Spartan Fire, LLC

Technical Service Bulletin TSB24-260-001

APPLIES TO: This service bulletin applies to certain model year 2023-2025 Metro Star and FC-94, 2023-2024 Gladiator, 2024 KME Predator, and 2024-2025 KME Panther model emergency response chassis cabs built between April 2023 and August 2024.

Figure 2.1

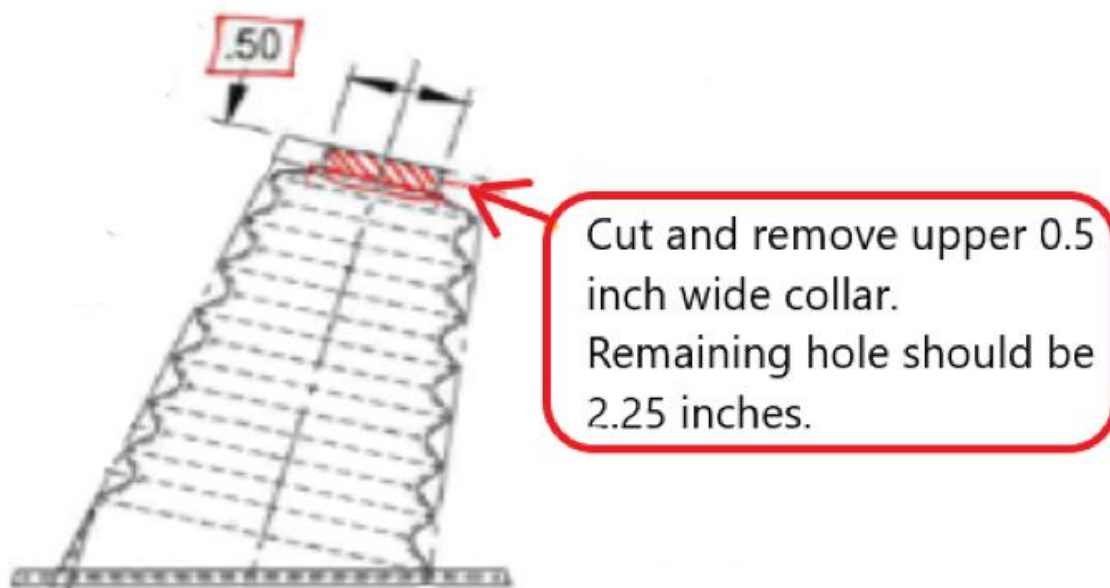
CONDITION: Certain steering boots are adhering to the steering column shafts, causing damage to the boots during steer events.

- 1) Locate steering column boot mounted to driver's floor.
- 2) Wipe away any grease from the area on both the steering shaft and the steering column boot.
- 3) Cut away the top 0.5 inch collar of the steering boot leaving a 2.25" diameter hole. See Figure 2.1

CORRECTION: Remove top collar of steering boot, increasing the top opening diameter from 2.00 inches to 2.25 inches to prevent adhesion to steering shaft.
